Traynor YCV40 - Presence Knob to master volume mod
 with reverb working correctly.

For early 2000's models

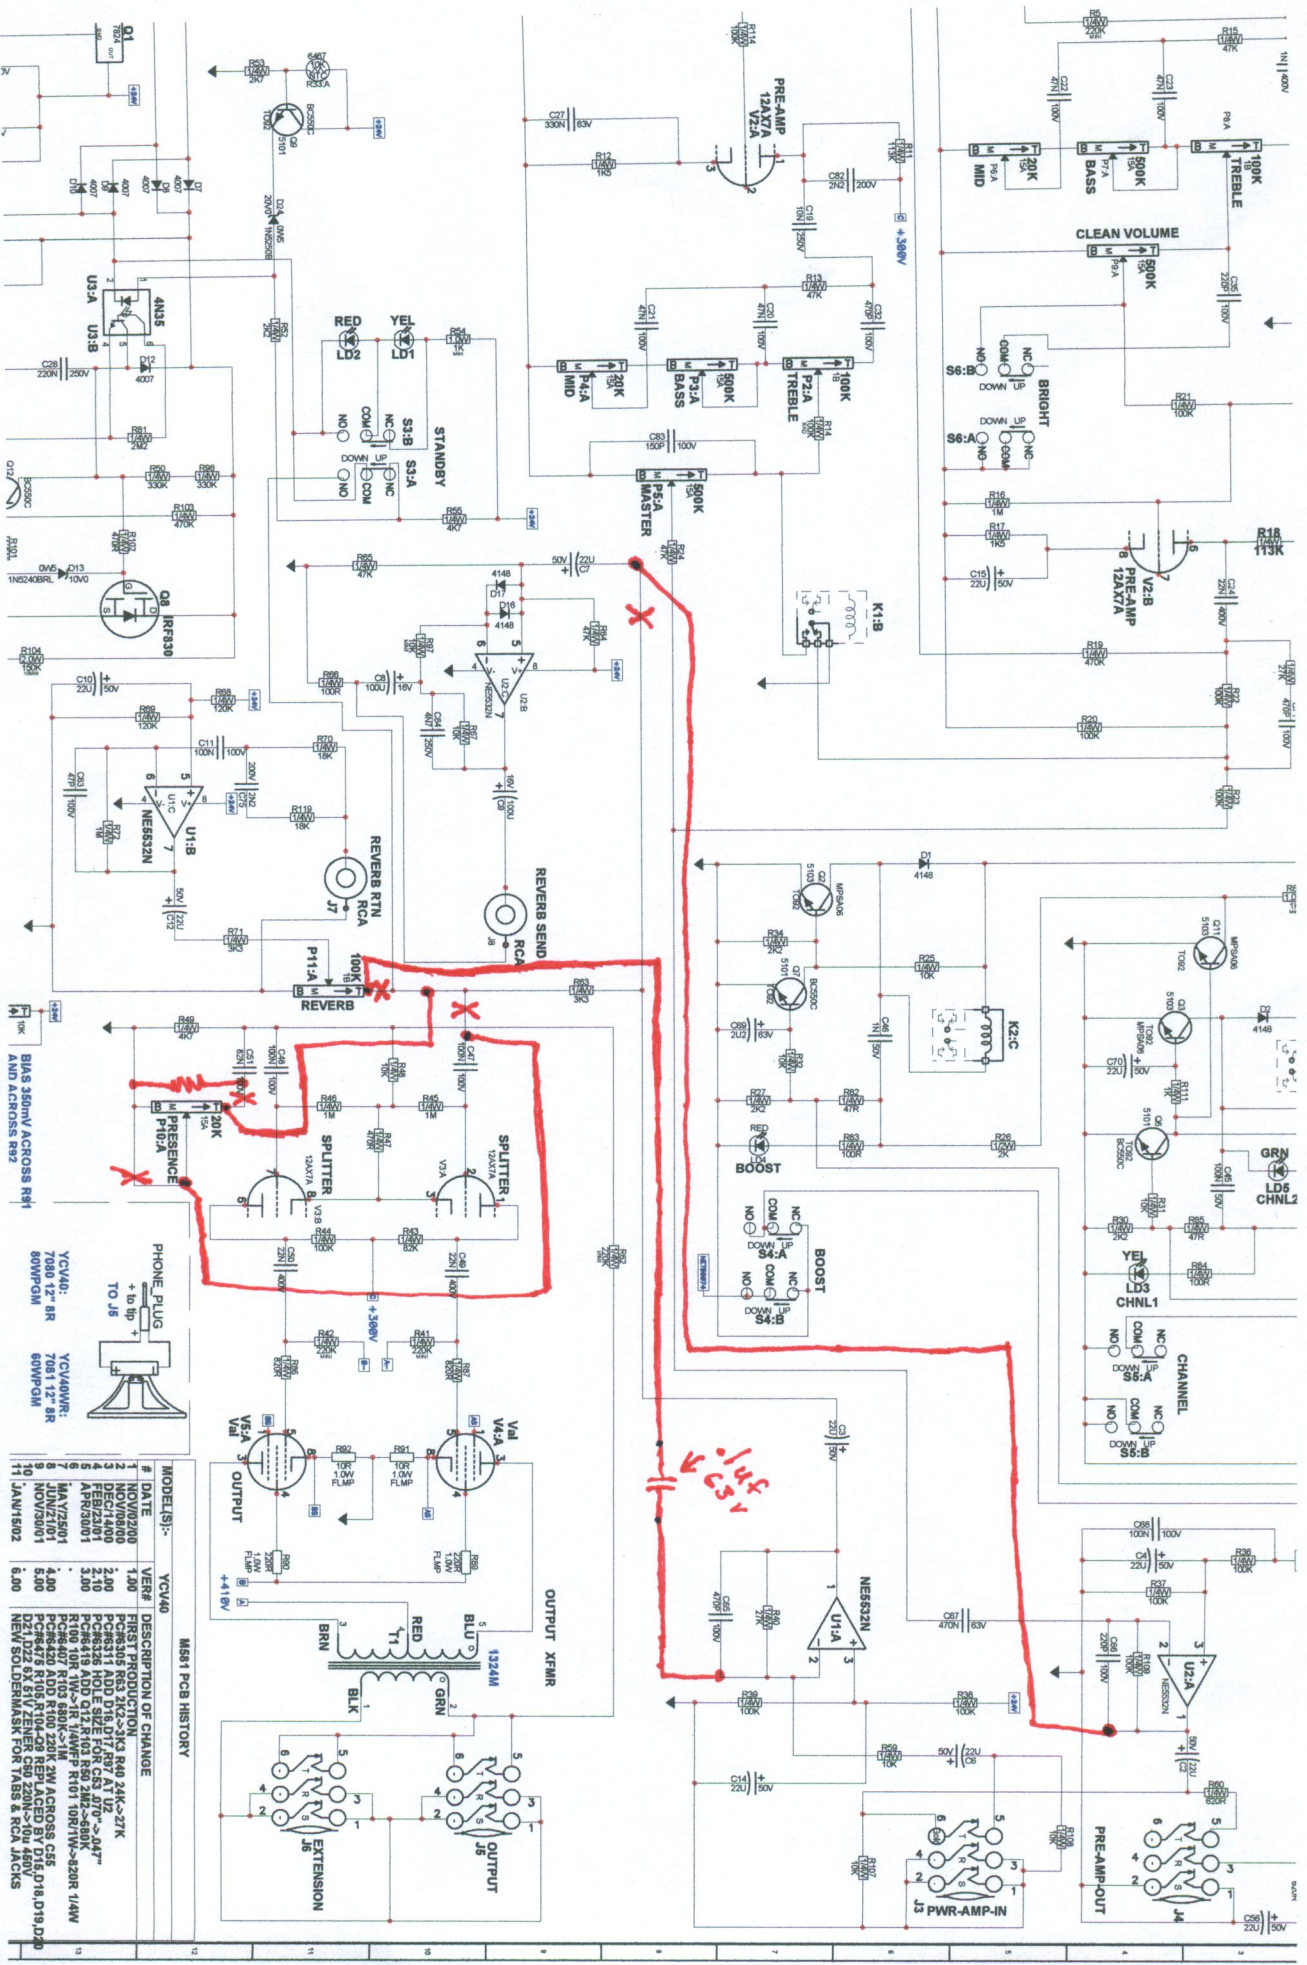
X = lot traces on circuit board.
